REGULATION No. 94  
(Protection of occupants against frontal collision)

Proposal for draft Supplement 4 to the 01 series of amendments to Regulation No. 94

Paragraph 6.2.1., amend to read:

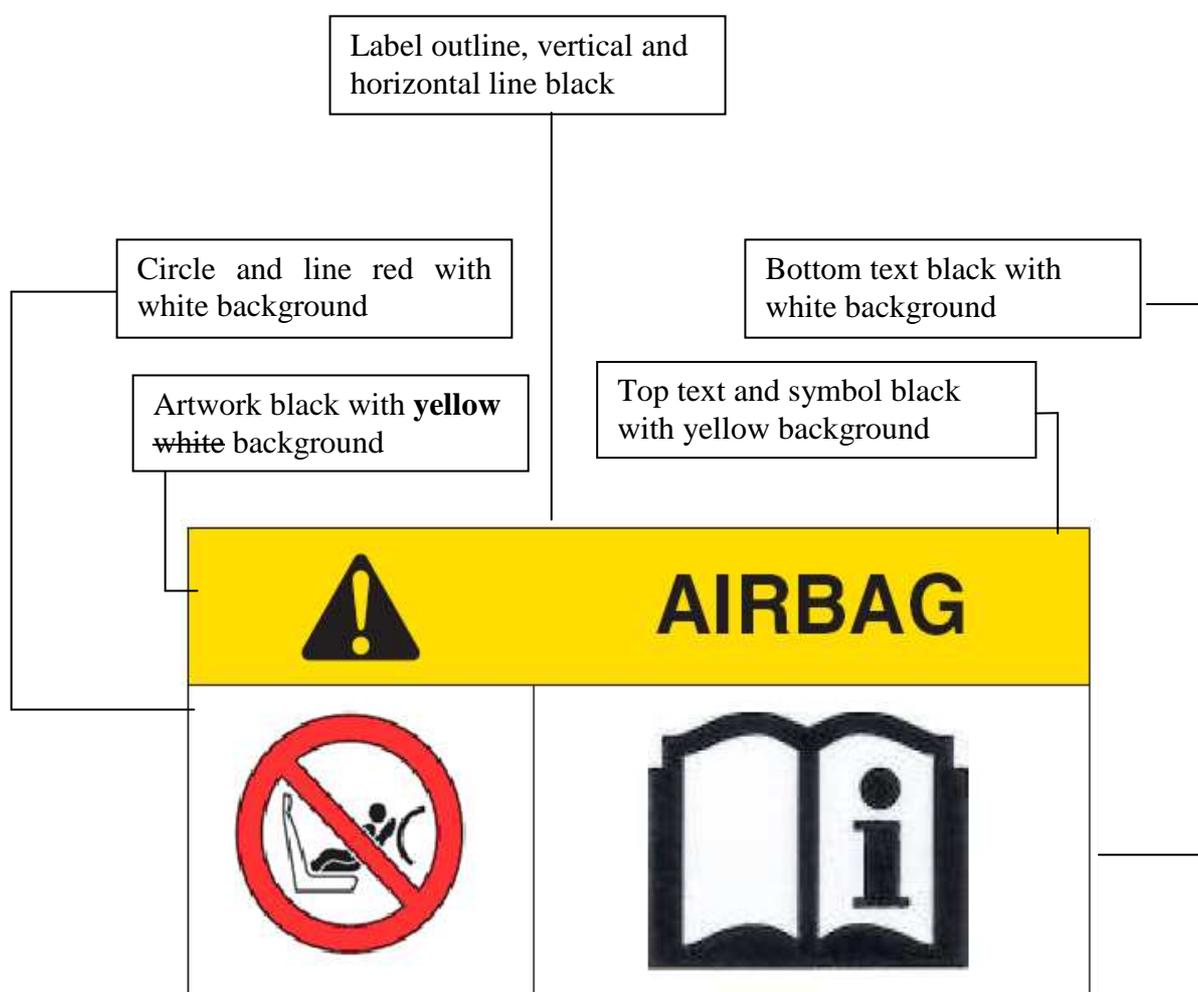
"6.2.1. As a minimum, this information shall consist of a label containing a pictogram ~~and text~~ warning, **an example of which is** as indicated below.

The overall dimensions shall be ~~120 x 60~~ **80 x 40** mm or the equivalent area, as a minimum.

The label shown above may be adapted in such a way that the layout differs from the example

above; however, the text content shall meet the above prescriptions."

In order to simplify the situation, it is consequently proposed to replace the current requirements by a pictogram which would ensure that the minimum required information is readily given to the consumer, whereby all further details would be found in the owner's manual.
